ADDENDUM NO. 1

Issue Date:	March 12, 2026
School / Facility Name:	Spirit Elementary
Project Name:	Upgrade HVAC Bldg. 7
Owner's Project No.:	2648250

Owner:	School Board of Volusia County Florida 200 N. Clara Avenue, DeLand Florida 32720
Owner's Project Manager:	Mike Semon
Project Manager's Location:	3750 Olson Drive, Daytona Beach Florida 32124

M101

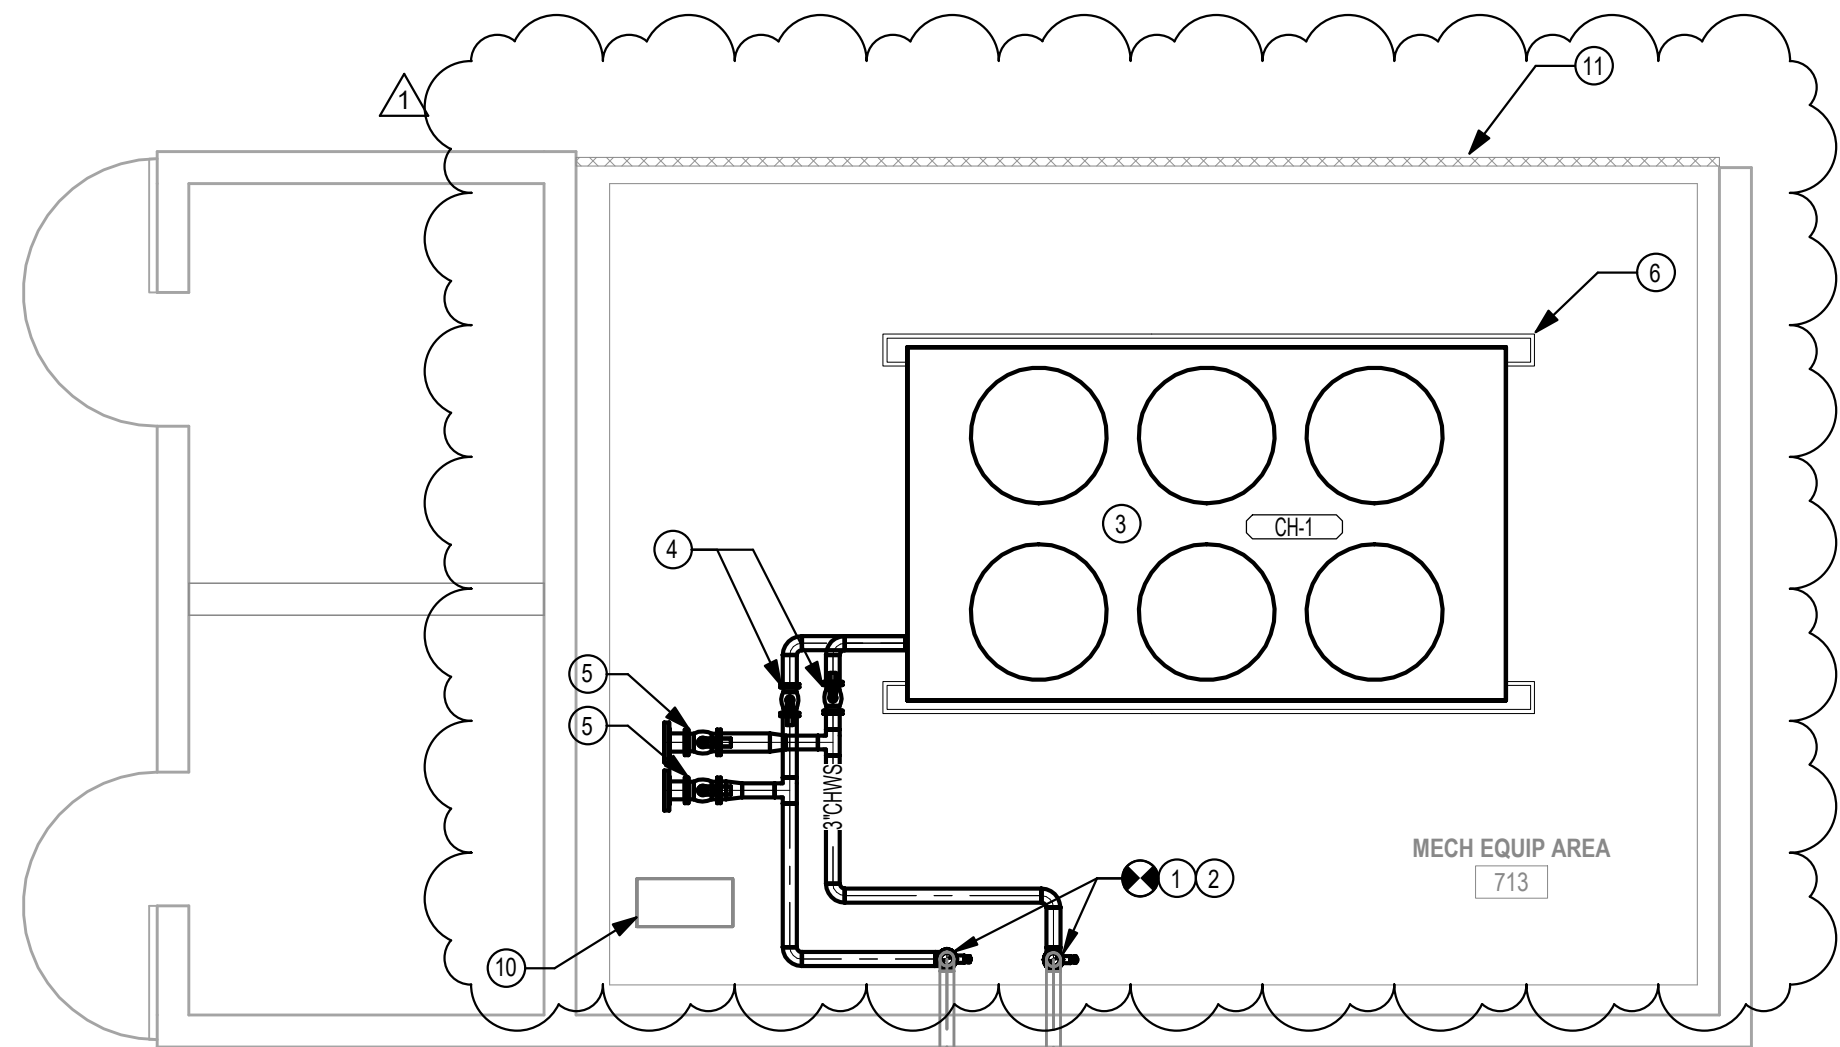
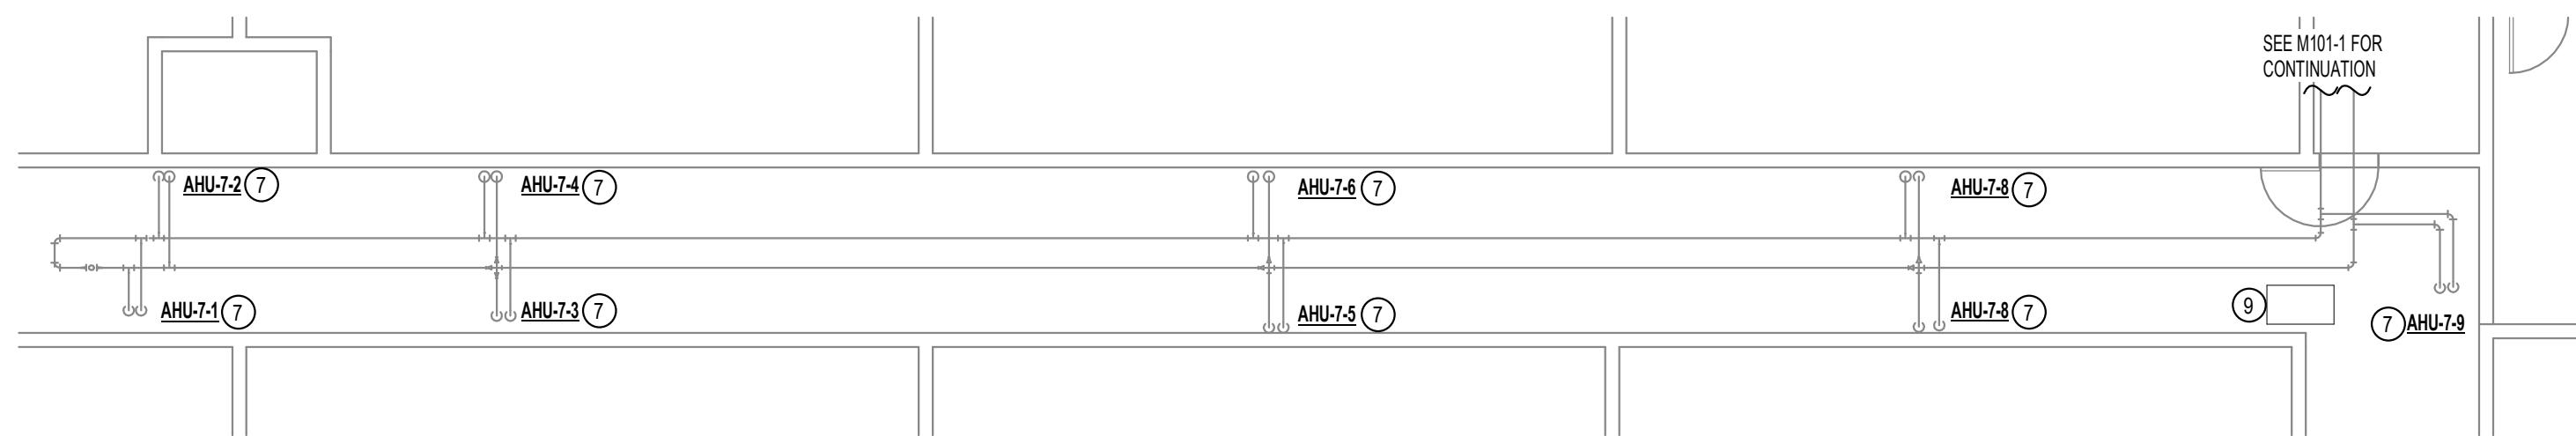
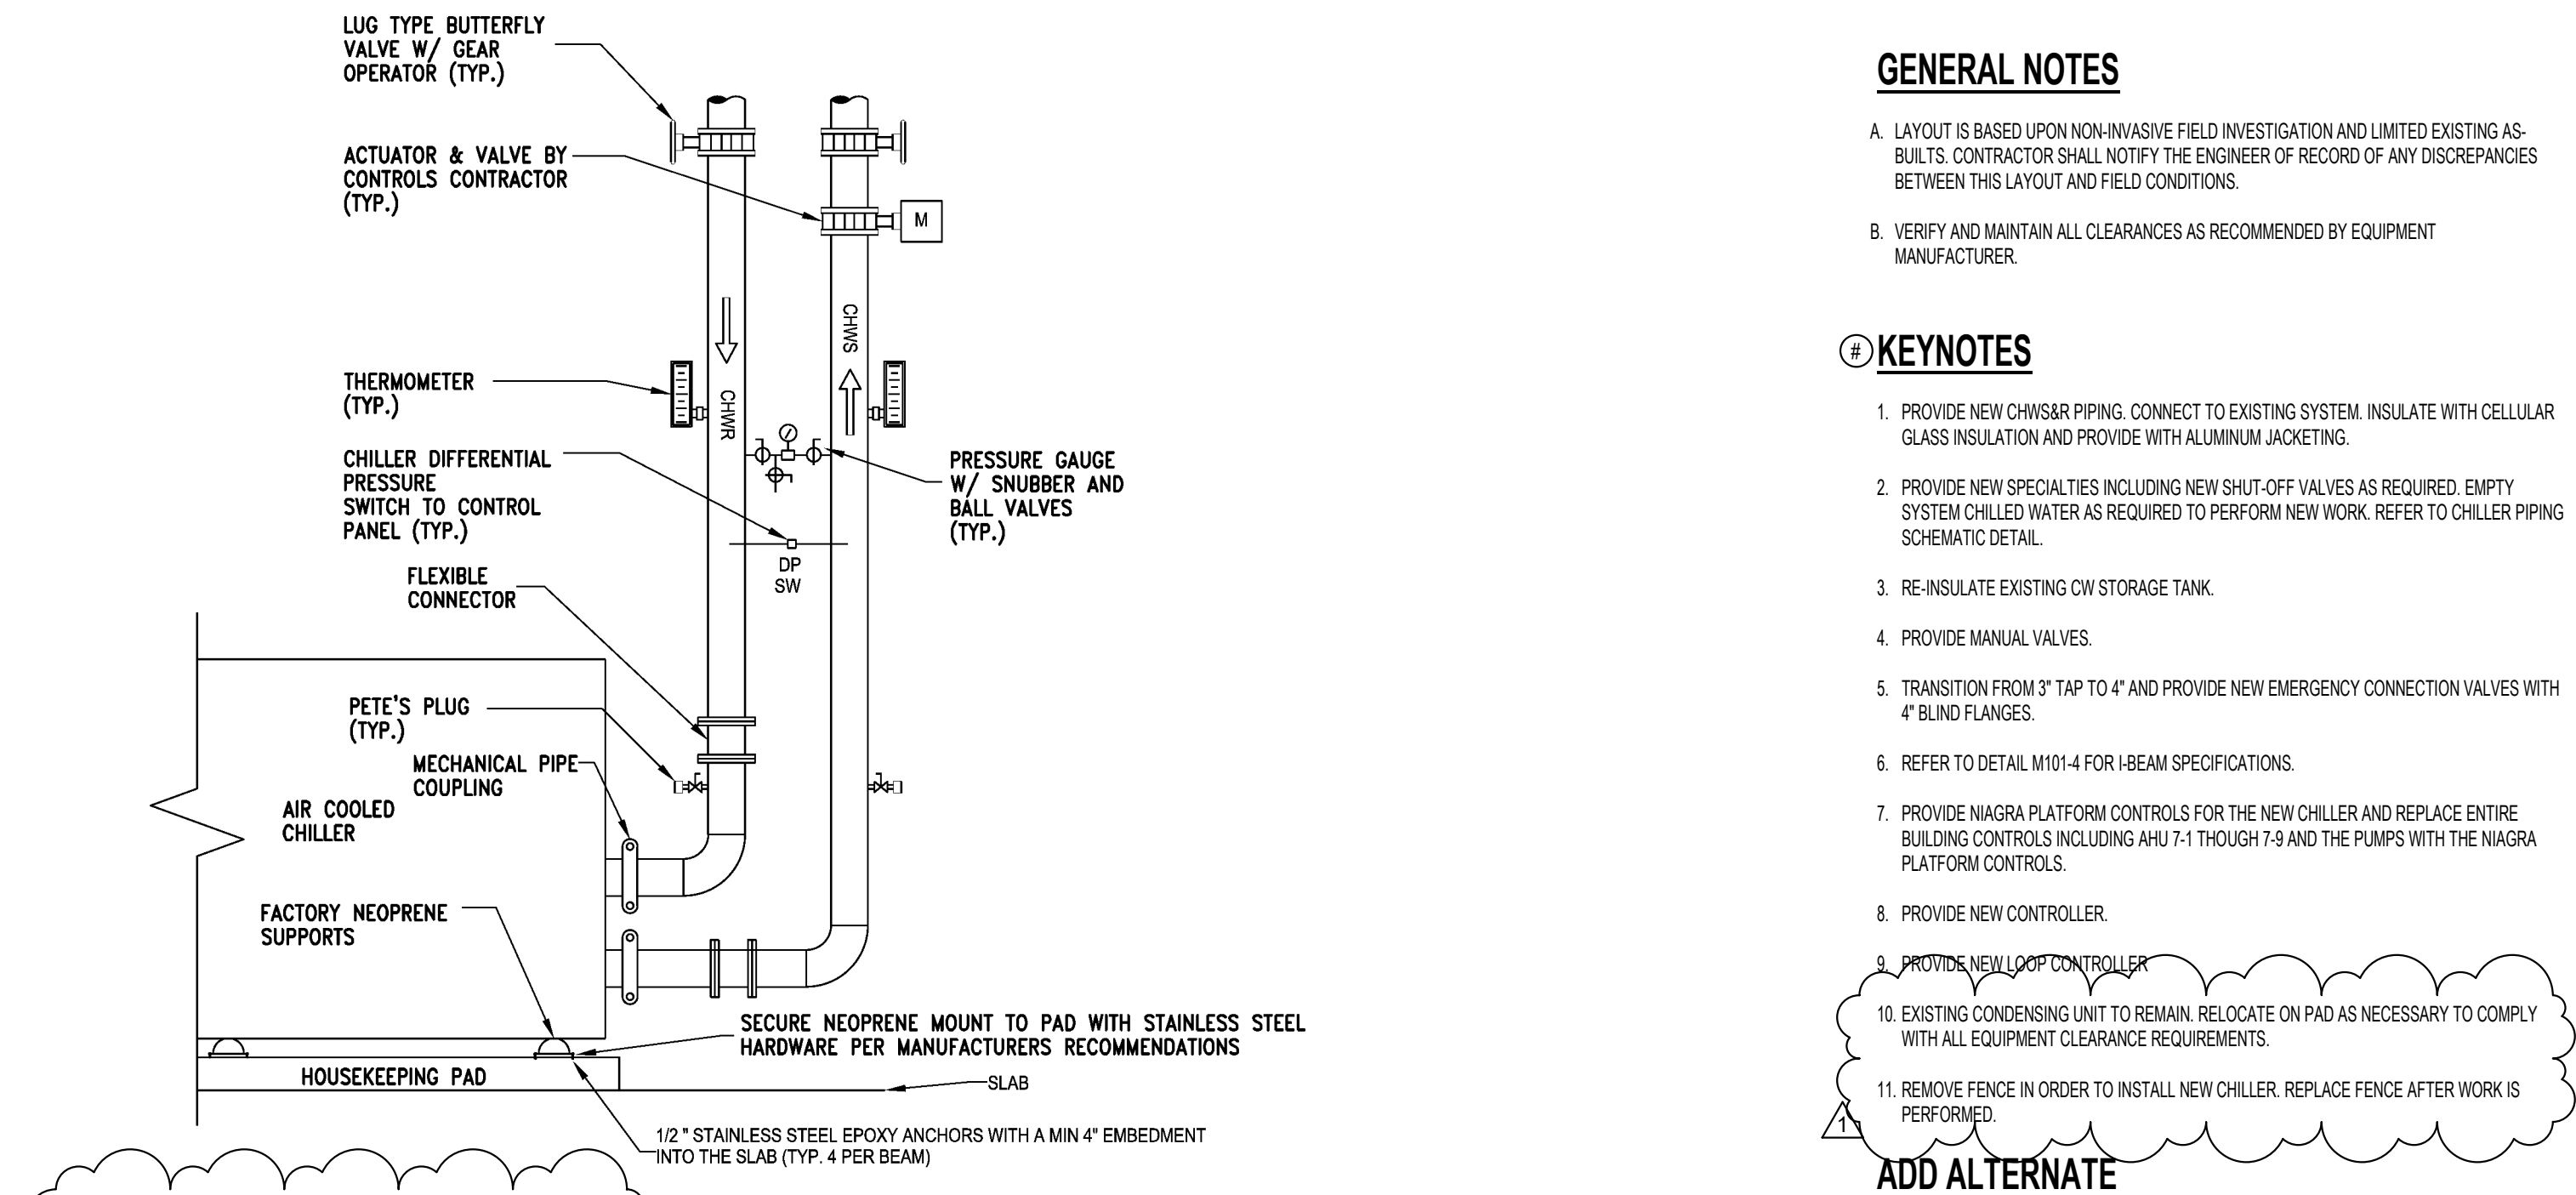
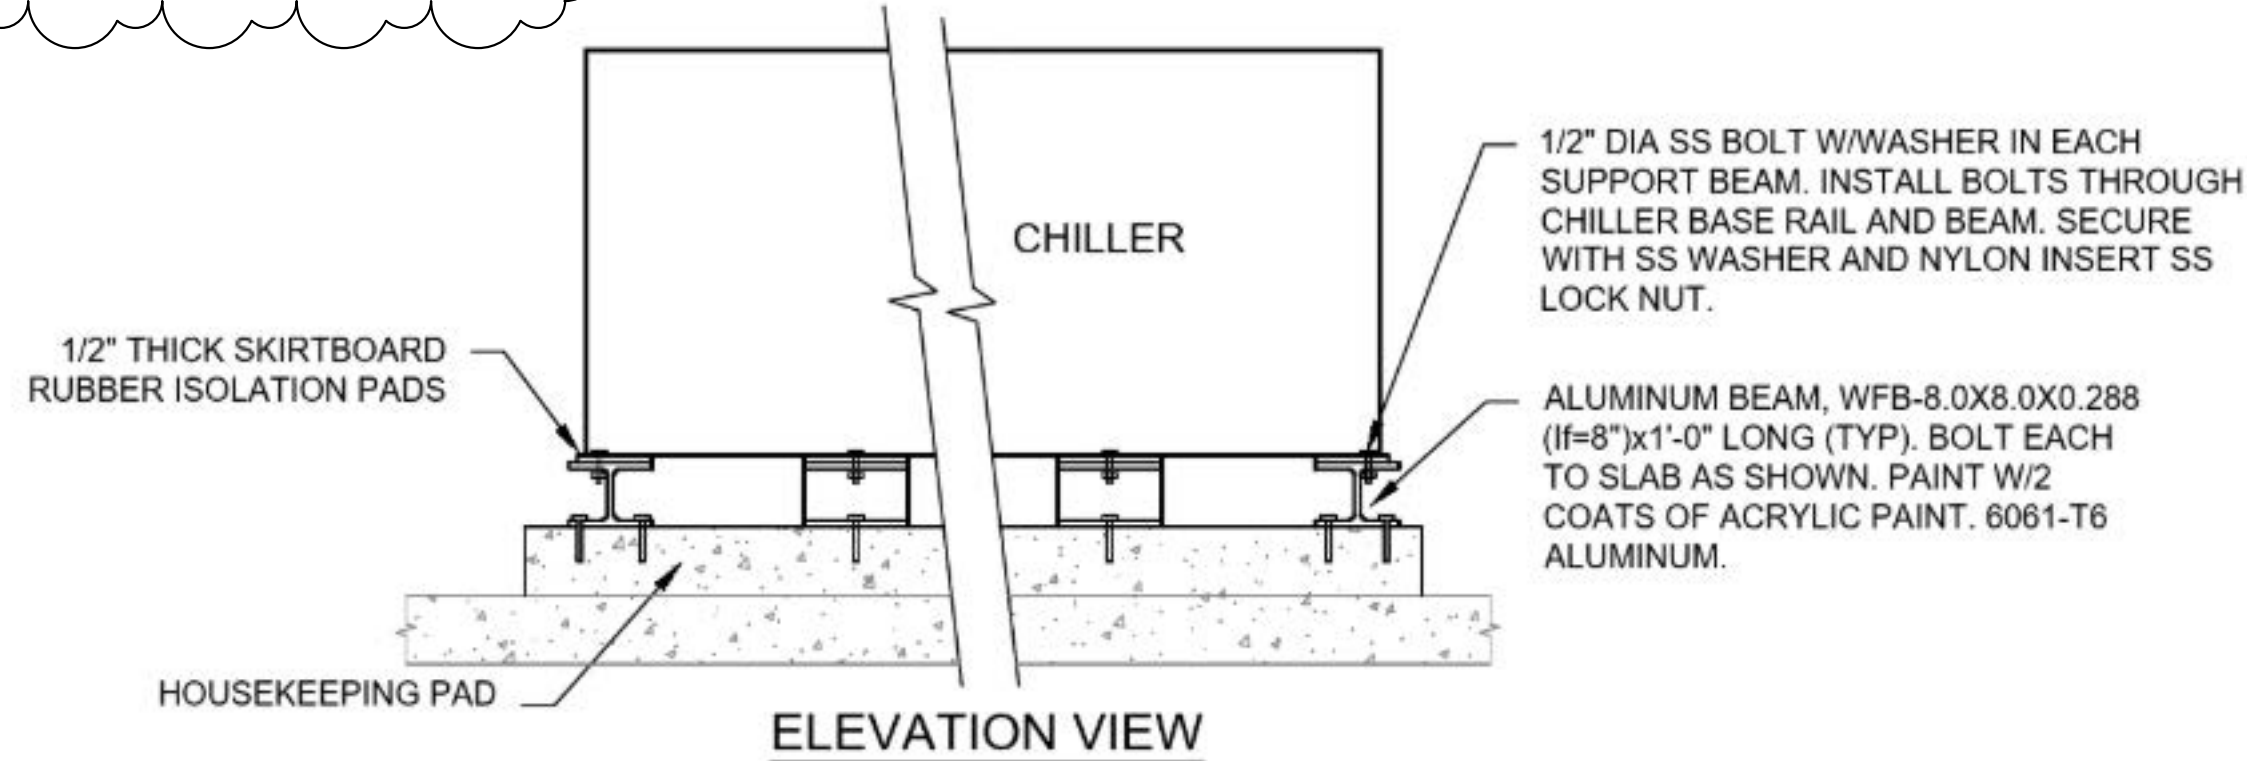
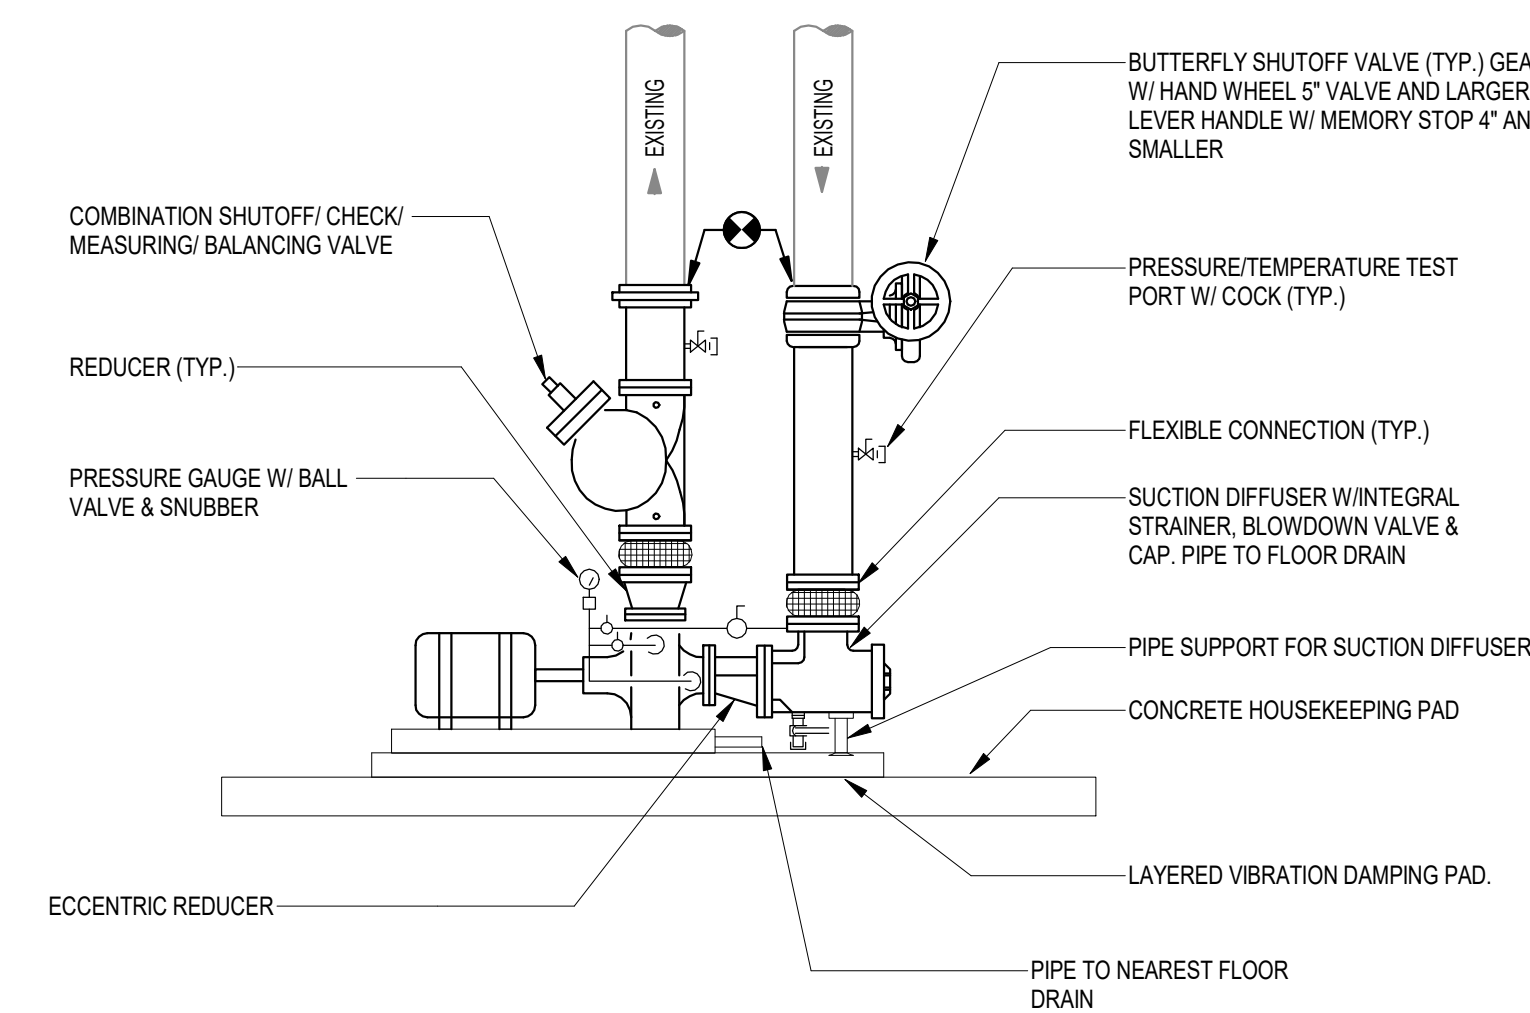
M101 Mechanical Plan:

Sheet revised to include existing condensing unit and fence, and revised chiller location.
